Needwood Road Bike Path/Trail, CIP No. 501304, Mandatory Referral No. 2015021

Description

Mandatory Referral approval is requested for the Montgomery County Department of Transportation’s project to construct an 8-foot-wide shared use path along 1.9 miles of Needwood Road Bike Path between Deer Lake Road and Muncaster Mill Road (MD115).

Needwood Road at Needwood Lake Causeway

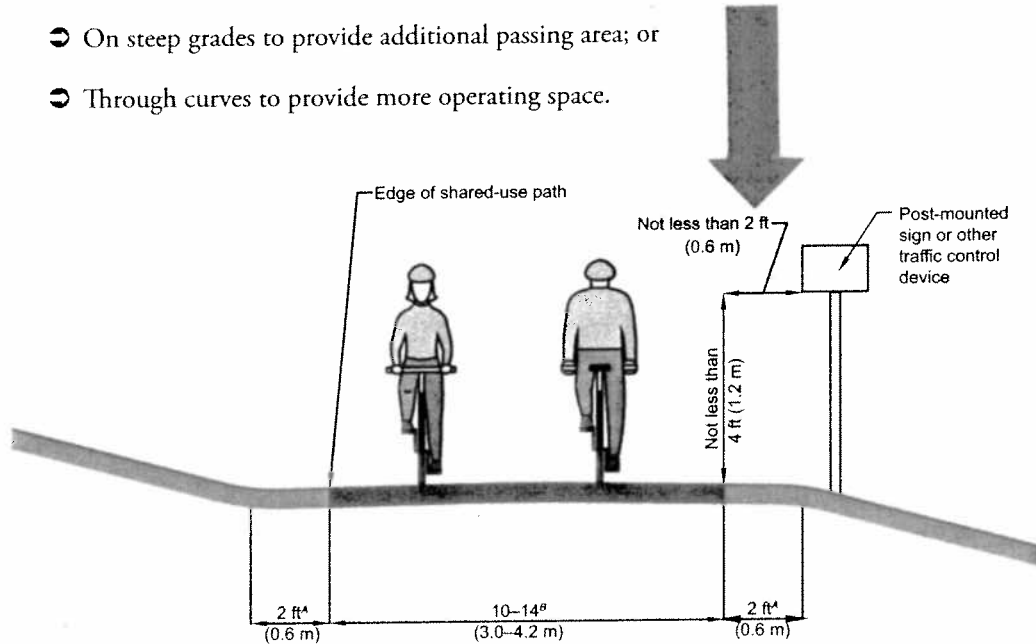
The proposed shared use path would be built in the existing eastbound shoulder of Needwood Road. The existing westbound shoulder of Needwood Road would remain. The photo below illustrates the existing roadway typical section in the most constrained segment of the project, which is on top of the earthen causeway between the main part of Lake Needwood and the forebay. It measures approximately one-quarter mile. The bike lanes in this segment would not be provided and could be made more difficult to construct in the future.

The most constrained segment of the project is approximately one-quarter mile long and centered on the bridge. There are multiple issues with the proposed design in regard to national design standards that need to be evaluated and reconciled:

Consistency with National Design Standards: AASHTO recommends that a two-foot minimum clearance to lateral obstructions be provided on each side of a shared use path (see Attachment 7). For almost the entire constrained segment, only a one-foot clearance would be provided.

For the edge of the shared use path adjacent to the roadway, AASHTO recommends that a minimum of five feet of separation be provided between the edge of roadway and the shared use path (see Attachment 6); where the separation is less than five feet, a physical barrier or railing should be provided to prevent path users from straying into the roadway and to reinforce that the path is an independent facility. Only a three-foot wide buffer is proposed in the submitted design but MCDOT has expressed a willingness to include bollards or flexposts in the buffer. This would meet AASHTO's requirement aimed at preventing path users from straying to the roadway but not our concern about vehicles straying into the path; presence of the bollards would reduce the effective width of the buffer from three feet to about one foot to the lateral obstruction posed by the bollard.

MCDOT Proposal

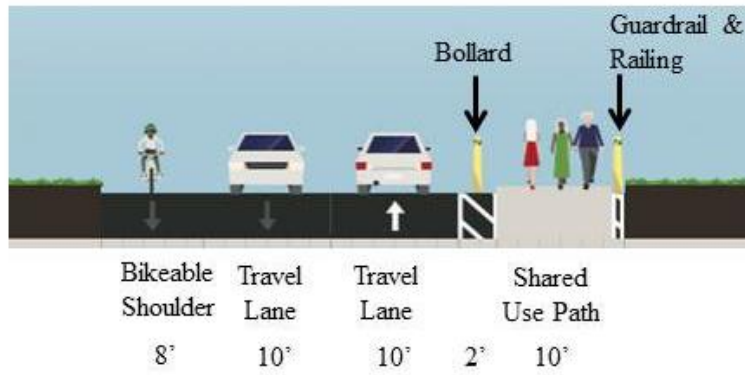
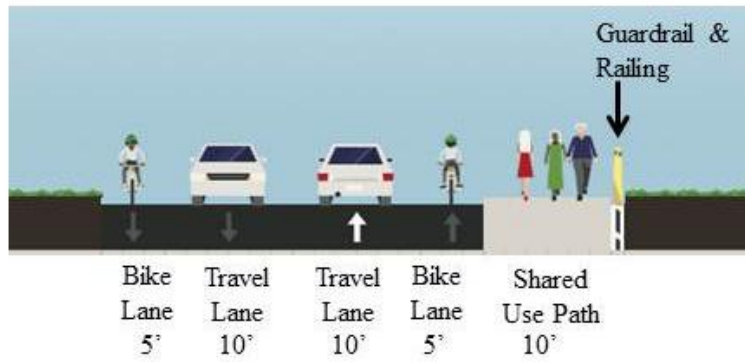
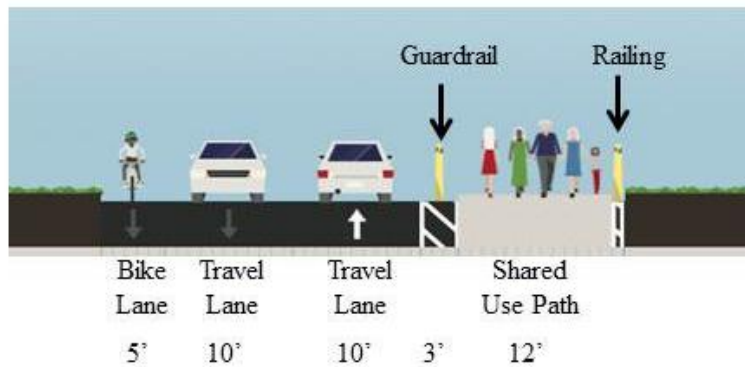
We see two potential solutions that would meet Objective D, and provide the master plan-recommended bike lanes. Both involve shifting the centerline of the roadway three feet to make use of a portion of the eight-foot-wide paved shoulder on the opposite side of the roadway without increasing the overall pavement width. A five-foot-wide bike lane would be provided in the remaining shoulder of westbound Needwood Road, as shown in the County standard on Attachment 2. A comparison of the typical sections in the constrained area for the proposed condition and the two alternatives is shown as Attachment 9.

The first alternative would be to construct a 10-foot-wide raised shared use path adjacent to a five-foot-wide eastbound bike lane. While the curb would not provide as much protection for path users as relocating the guardrail, it would deter errant vehicles to some extent. The drawback to this alternative is that the presence of a curb would channel stormwater runoff that would have to be collected and discharged. This alternative would meet the master plan recommendation for a dual bikeway in the constrained area.

The second alternative would be to install a guardrail in the buffer at a one-foot-wide offset from the ten-foot-wide eastbound travel lane. This would leave twelve feet of space for pedestrians and bicyclists rather than the proposed ten feet (the eight-foot-wide path plus a one-foot-wide buffers on either side of the path). The wider space would provide more flexibility for path users and would minimize conflicts between bicyclists and pedestrians who will naturally stay as far away from the roadway as they can. This segment of Needwood Road is at the base of two hills and cars tend to naturally increase their speed above the 30 mph posted limit as they approach this area, so the guardrail

MCDOT's consultant is concerned that the guardrail would be too close to the travel lane. The AASHTO Roadside Design Guide says that the suggested shy line offset for a 30 mph design speed is 4'; this distance is set so that a roadside object will not be perceived as an obstacle that might result in a motorist's reducing speed or changing vehicle position on the roadway. It goes on to say, "*For long, continuous runs of railing, this offset distance is not so critical, especially if the barrier is first introduced beyond the shy line and gradually transitioned near the roadway.*" At 300 feet and 900 feet, both segments of guardrail qualify as long continuous runs where the offset distance is not so critical. Also, this shy distance is a suggested value whereas the placement of the guardrail between the roadway and sidewalk/path is a recommended practice. The latter is stronger than "suggested" and should be the governing consideration. This would also not be a unique condition. See the photos below of Norbeck Road (MD28) and Veirs Mill Road (MD586) as two examples.

1. Construct one of the two alternatives below as the permanent solution to be included as a condition of the park permit, with completion of the selected alternative to occur as part of the Phase 2 construction:
 - a. Construct a 10-foot-wide raised shared use path adjacent to a five-foot-wide eastbound bike lane; or
 - b. Install guardrail in the buffer at a one-foot-wide offset from the ten-foot-wide eastbound travel lane and provide a twelve-foot-wide two-way shared use path behind the guardrail.
